ISSUE: Certificate of Appropriateness for new construction

APPLICANT: Ala Awadallah

LOCATION: Parker-Gray District
1417 Princess Street

STAFF RECOMMENDATION

FRONT ELEVATION (SOUTH)
SCALE: 1/4" = 1'-0"

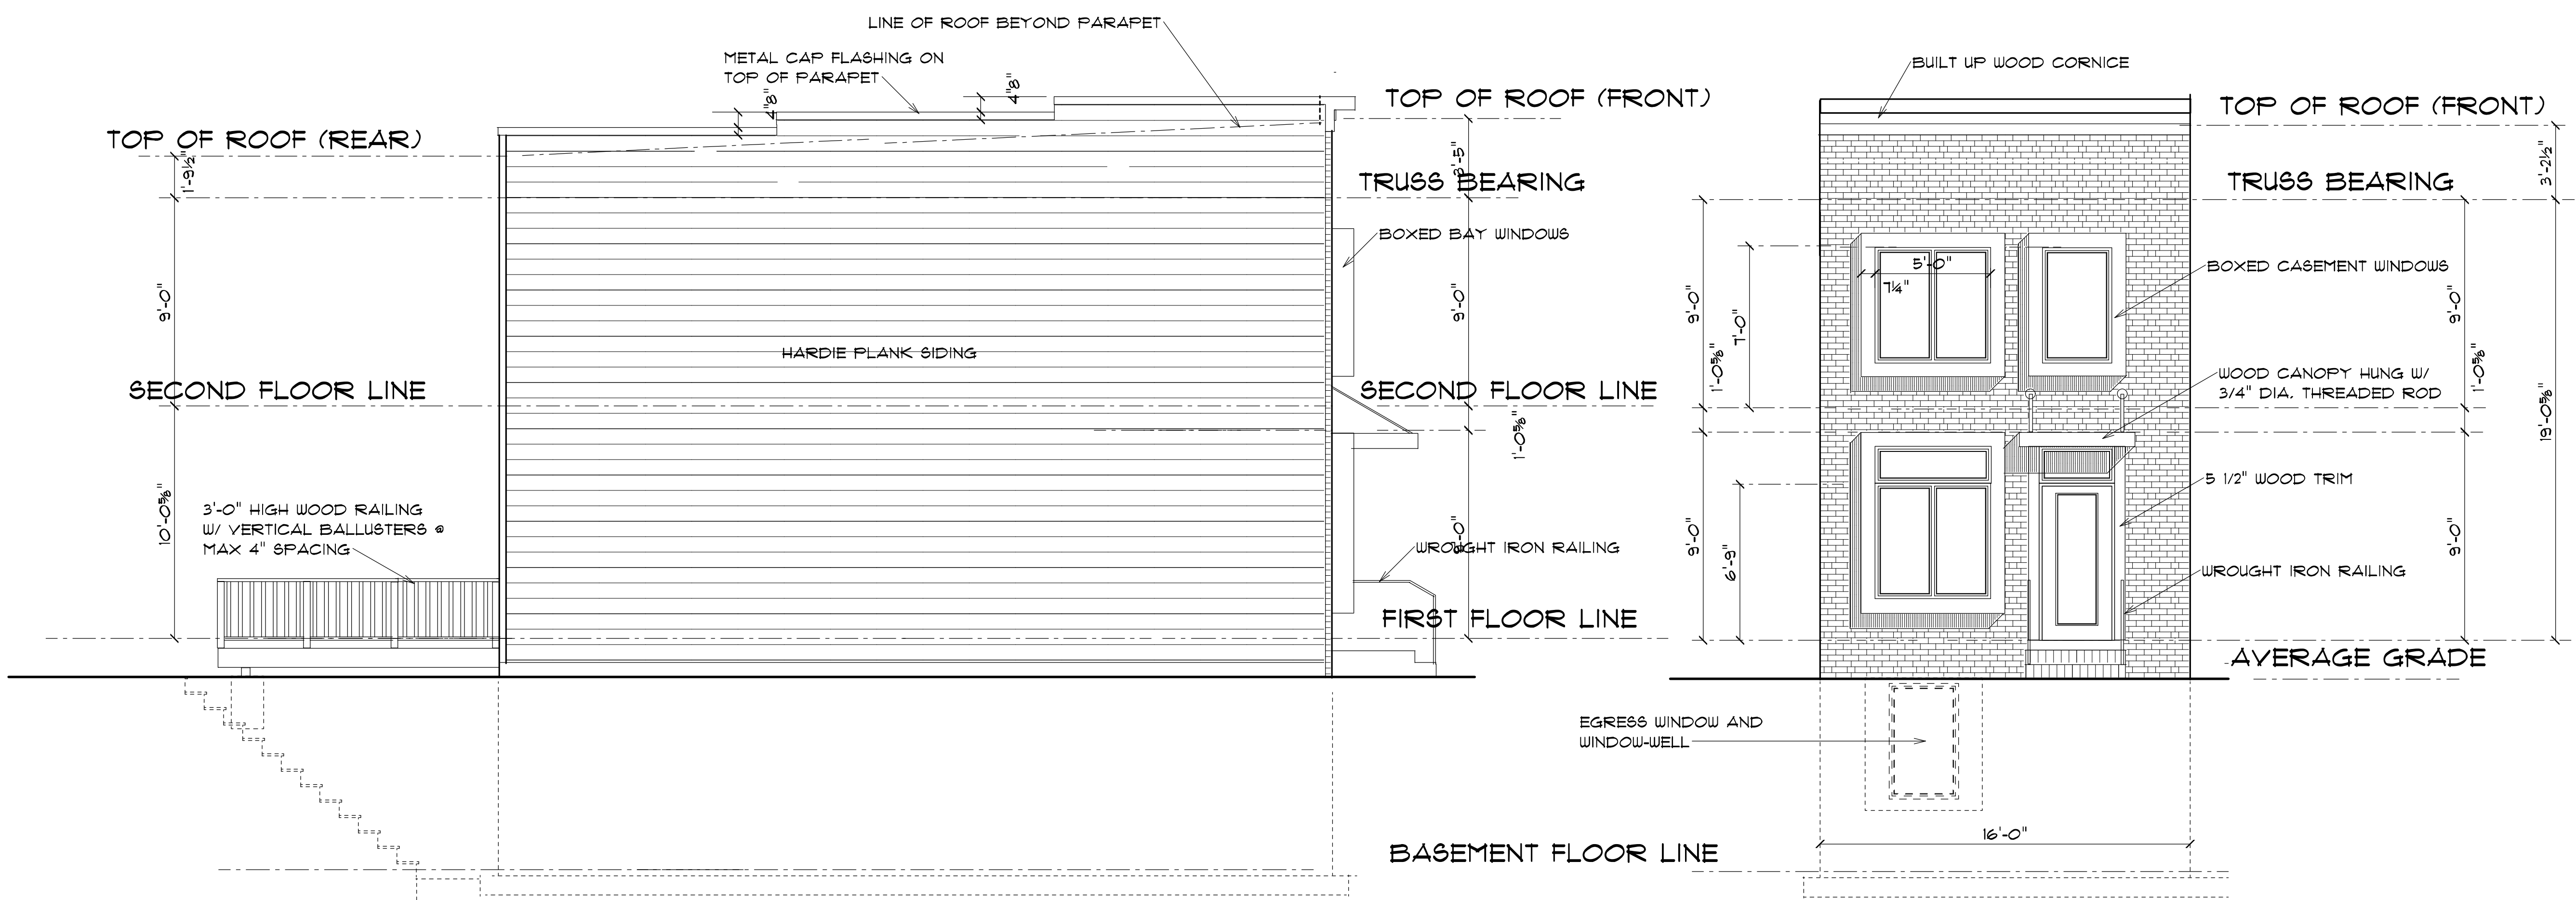
1. Restudy of the area between the second-floor windows and the cornice on the south elevation with final details to be approved by staff during building permit review;
2. The color of the fiber cement siding must be the same value as the unpainted brick façade.
3. Include the language below on all construction documents involving any ground disturbing activities.
 - a. Call Alexandria Archaeology immediately (703-746-4399) if any buried structural remains (wall foundations, wells, privies, cisterns, etc.) or concentrations of artifacts are discovered during development. Work must cease in the area of the discovery until a City archaeologist comes to the site and records the finds.
 - b. The applicant shall not allow any metal detection and/or artifact collection to be conducted on the property, unless authorized by Alexandria Archaeology. Failure to comply will result in project delays.

The only feature staff recommends is to embellish the area between the second-floor windows and the cornice on the south façade. Because the roof slopes to the rear, this creates a large blank “forehead” above the “eyes” of the windows on the south face of the building. This area was historically filled with cast iron attic vents, or with a string course of contrasting color brick (Photo 2) or of a soldier course of brick or of decorative cast stone rectangles (Photo 1.) Staff recommends a simple design feature to reduce the scale of this relatively large blank area.

FRONT ELEVATION (SOUTH)
SCALE: 1/4" = 1'-0"

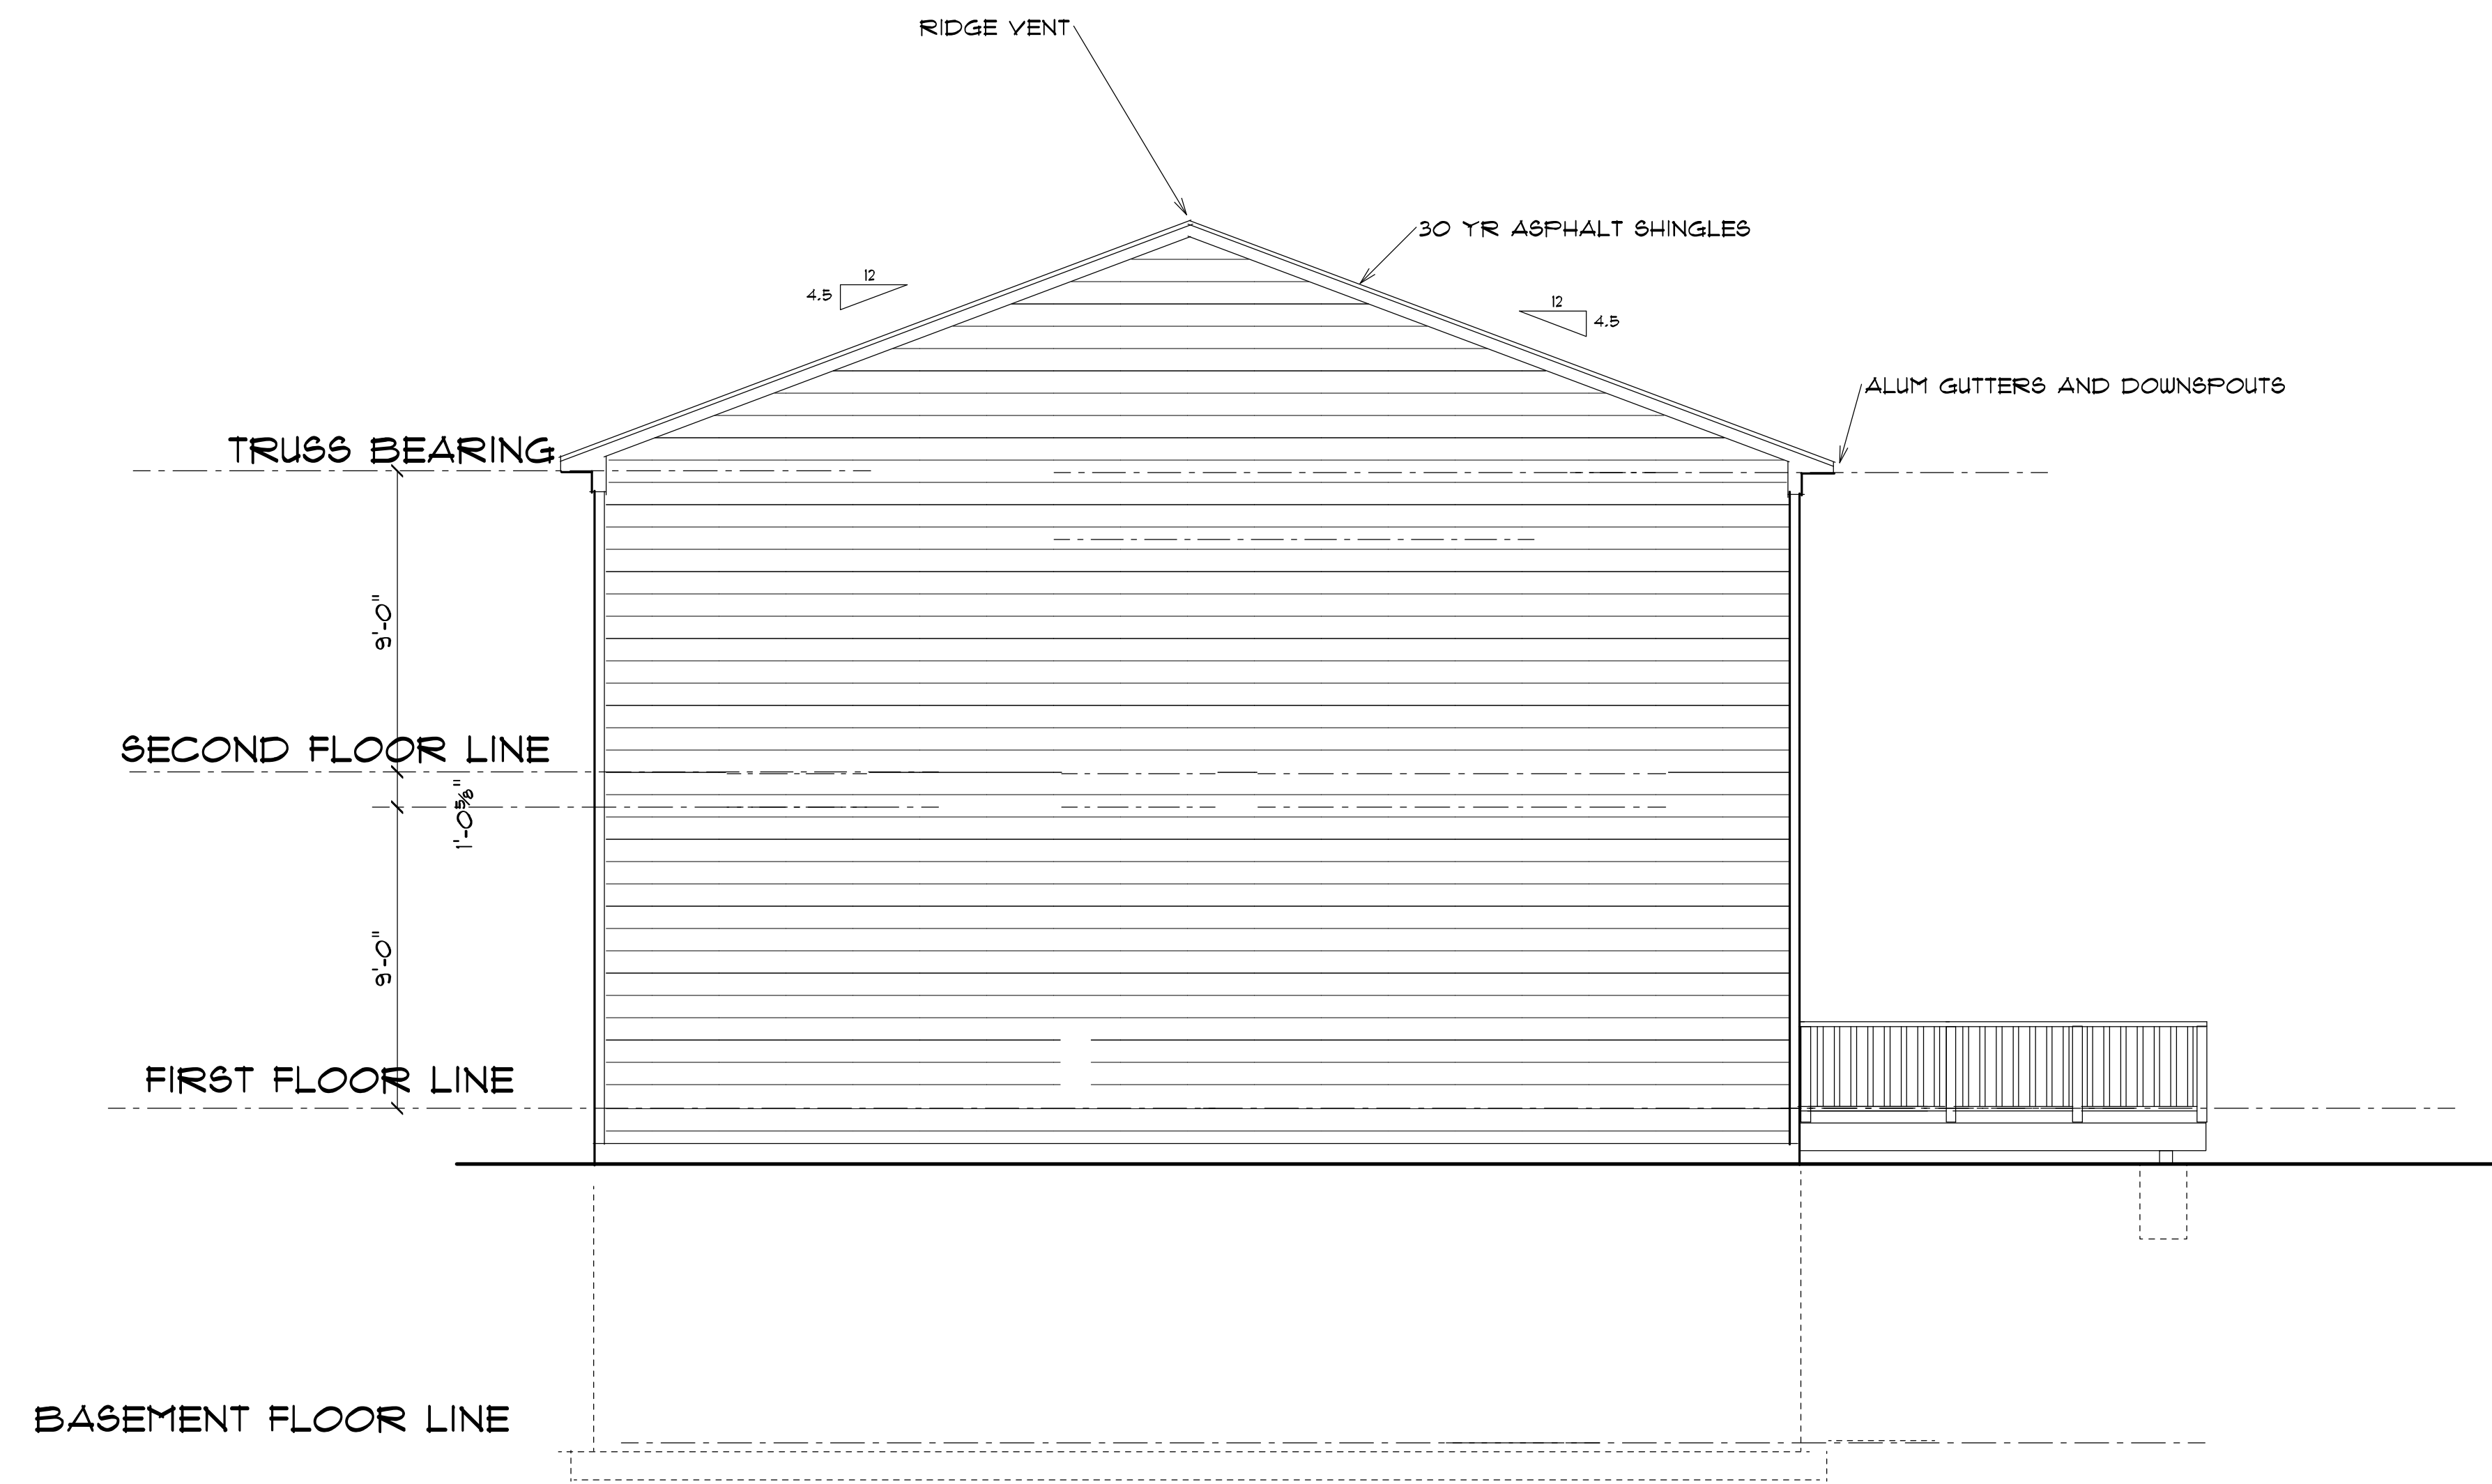
1. Approval of the scale, height, footprint and modified setback of 19' from the front lot line; and
2. Deferral of the design of the south elevation for restudy.

The Board supported the scale, height, footprint and modified setback of 19'. The Board recommended that the applicant restudy the south elevation to incorporate more modern
